STATION HILL READING

AMENDMENTS TO PLANNING PERMISSION REF:
192032/PHASE 2 STATION HILL

JULY 2023 - REV A

Changes to the Pocket Park and Planters to the Upper Ground

The key changes

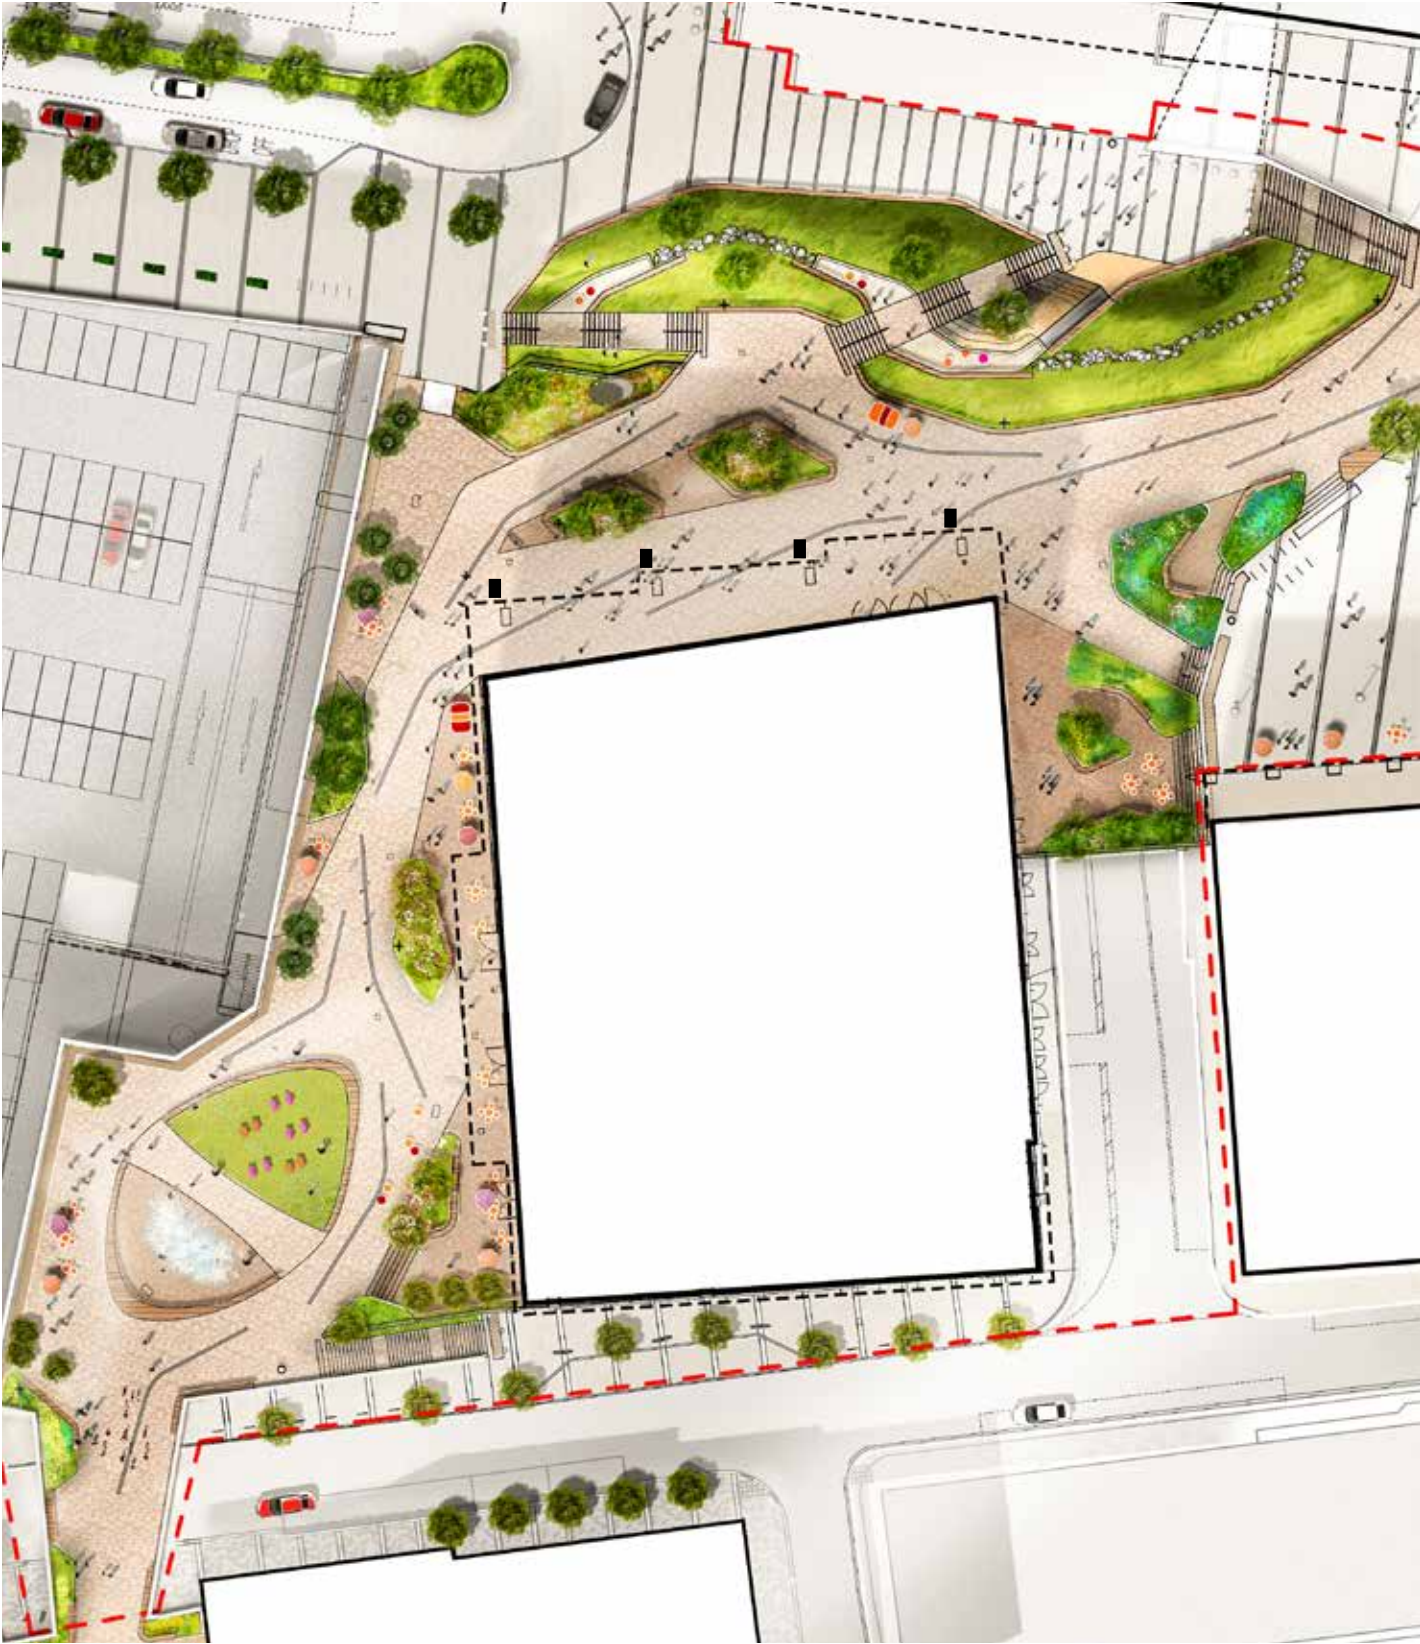
- The footprint of the Pocket Park is adjusted so that the alignment of the existing taxi rank does not need to be modified. This necessitates a slight alteration to the north-western boundary of the retaining wall/bench and planting at the lower level. The overall area increases from 1,066m² to 1,158m².

- The eastern set of steps leading from the lower the upper levels are realigned to work more closely with desire line from the tunnel to the upper level.

- The western set of steps leading from the taxi rank/bus stop follow the line of the wall to the upper ground and deliver users more directly to Station Square.

- Planters at upper levels are rationalised to create clearer pathways that align with desire lines. There is no loss of green or soft planting areas. Additional trees are provided.

- There is no loss of seating area.
- Planters at upper ground have been combined to create more soil volume for trees, to create clearer pathways and a more clearly defined central gathering space. The number of trees has increased by one to 44 across the site.

- The slide from upper to lower levels previously proposed is removed in response to safety and public order concerns.

LANDSCAPE: COMPARISON OF CONSENTED AND PROPOSED

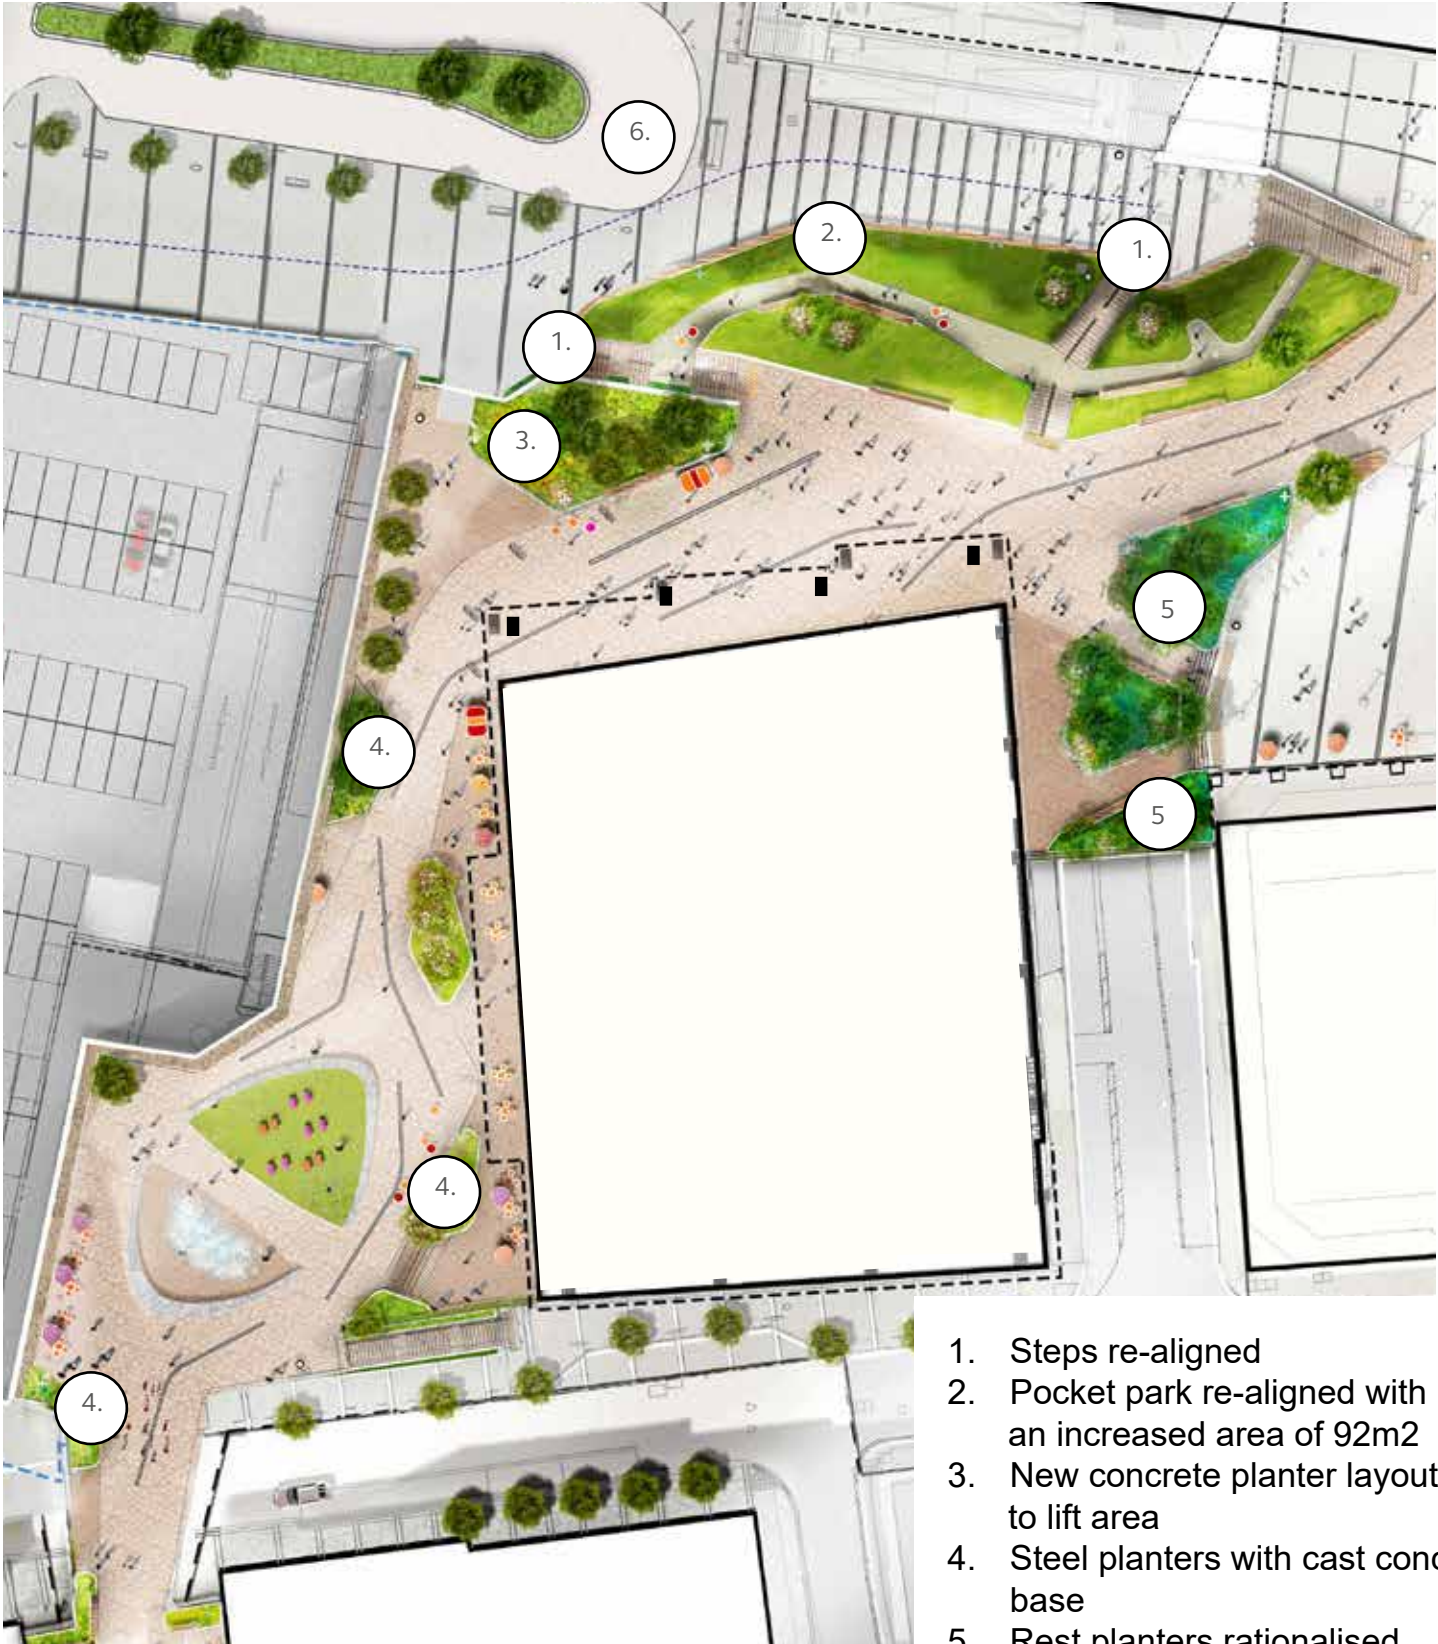
- 1. Steps re-aligned
- 2. Pocket park re-aligned with an increased area of 92m2
- 3. New concrete planter layout to lift area
- 4. Steel planters with cast concrete base
- 5. Rest planters rationalised
- 6. Taxi rank retained

PROPOSED CHANGES TO LANDSCAPE TO EAST OF ENTRANCE TO OFFICE BLOCK

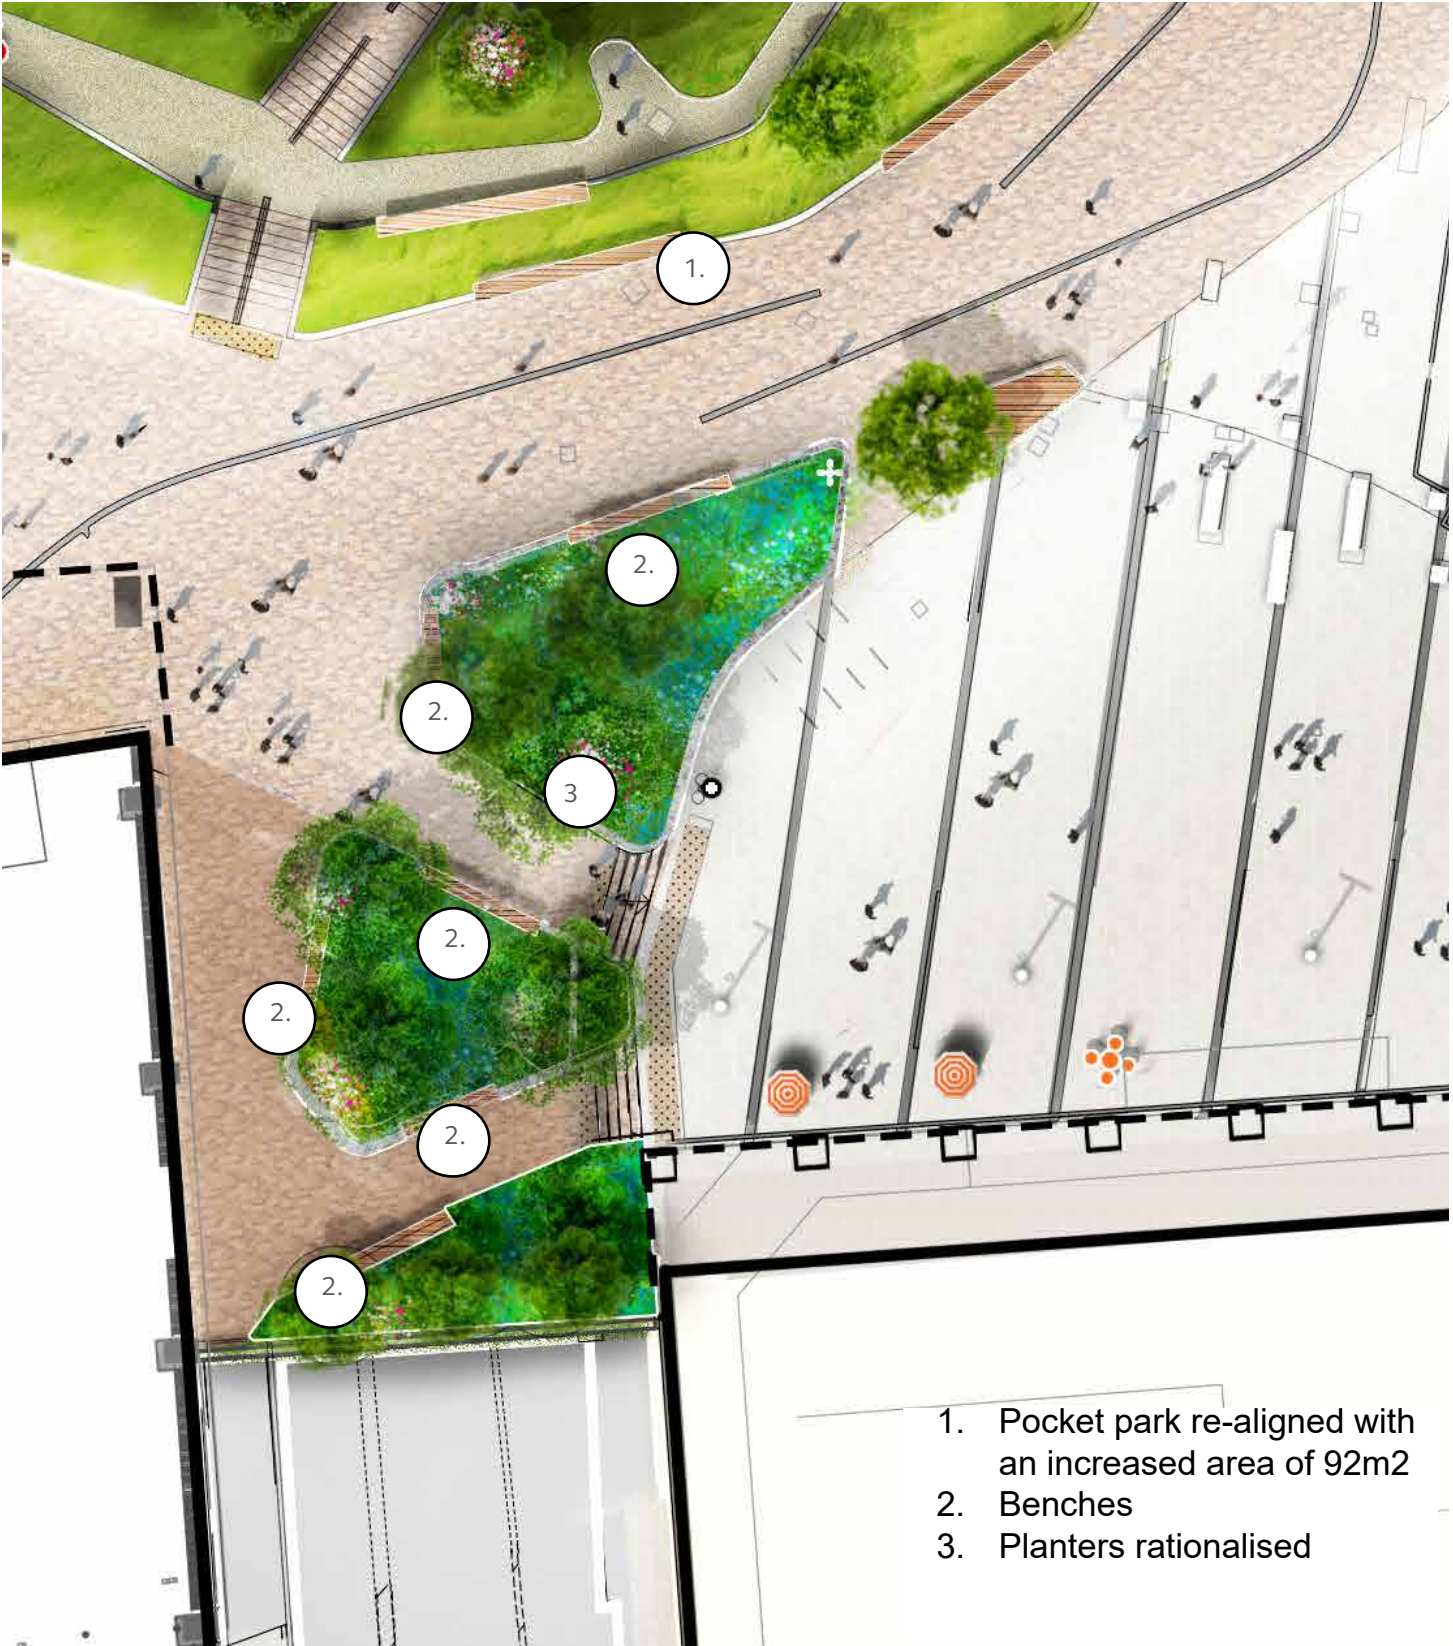
- 1. Pocket park re-aligned with an increased area of 92m2
- 2. Benches
- 3. Planters rationalised
